DEVELOPMENT APPLICATION ACCESSIBILITY REPORT

Project Name	Rutledge Street – Shop Top Housing
Project Address	Rutledge St and Crawford St, Queanbeyan NSW 2620
Reference	10442
Revision	2
Date	22/11/2022
Attention	Village Building Co.

5.5 Element 5 – Shower

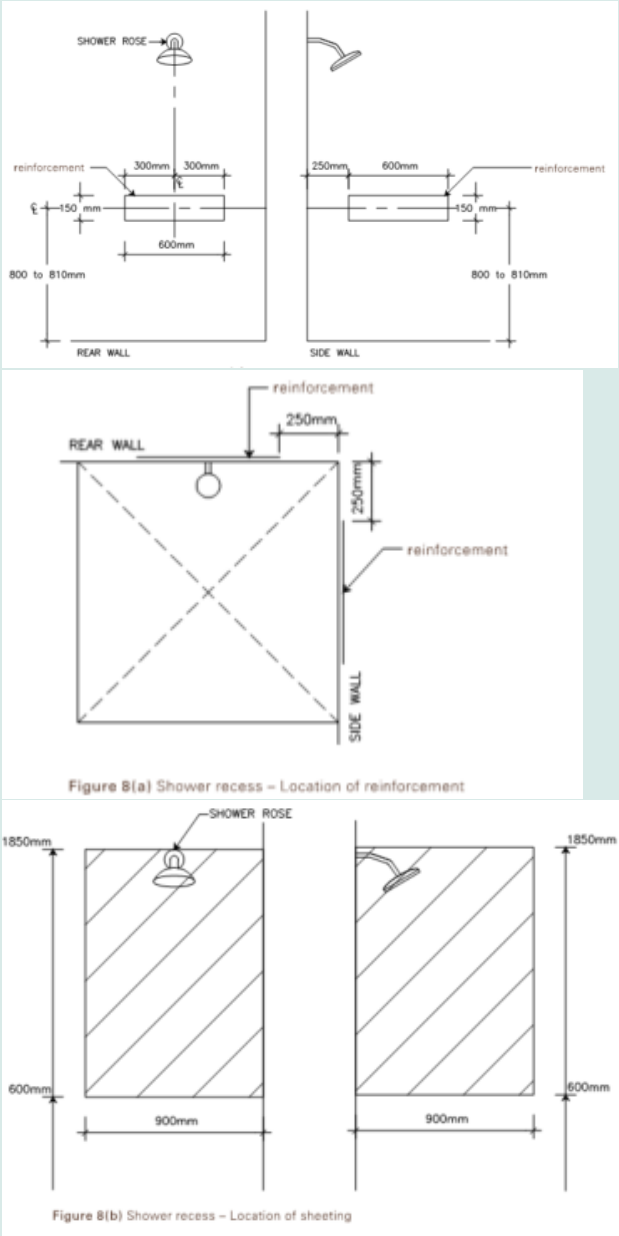
Silver Level Requirement		Comments
a.	One bathroom should feature a slip resistant, hobless shower recess. Shower screens are permitted provided they can be easily removed at a later date.	<p>The current design is capable of compliance with this requirement.</p> <p>Detailed design to be assessed at the Construction Certificate stage.</p>
b.	The shower recess should be located in the corner of the room to enable the installation of grabrails at a future date.	<p>The current design is capable of compliance with this requirement.</p> <p>Detailed design to be assessed at the Construction Certificate stage.</p>
Note	For hobless specification please see AS3740-3.6.
